# Dixie-Narco®

## Service Bulletin # 380

MODELS: Coke Landscape Only

SUBJECT: Adapter plates for control panel when supplying welded assembly main doors.

Figure 2

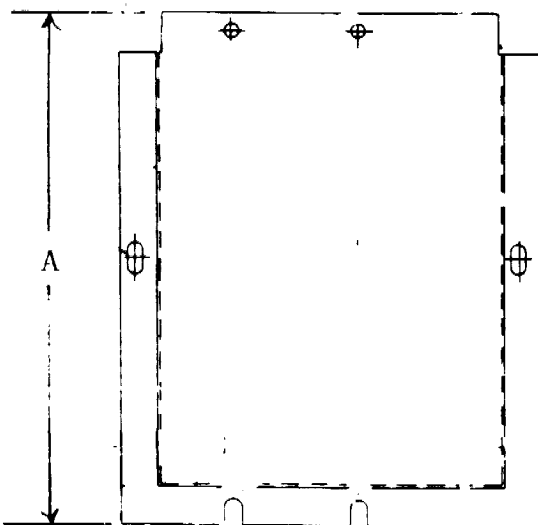
REASON: To utilize one (1) height welded assembly main door for each Landscape Coke cabinet by the use of adapter plates. Adapter, when required will be factory installed.

DO THIS: Place the bottom of U shaped template onto the bottom offset of the plastic control panel. Drill four (4) 7/32" holes four places if all four are needed. Align holes with studs on door and secure. Secure studs at top of adapter thru existing holes at bottom of plastic control panel.

A - 4 15/16" - B447,010,010.03  
A - 6 7/16" - B448,010,050.03  
Adapter Plates
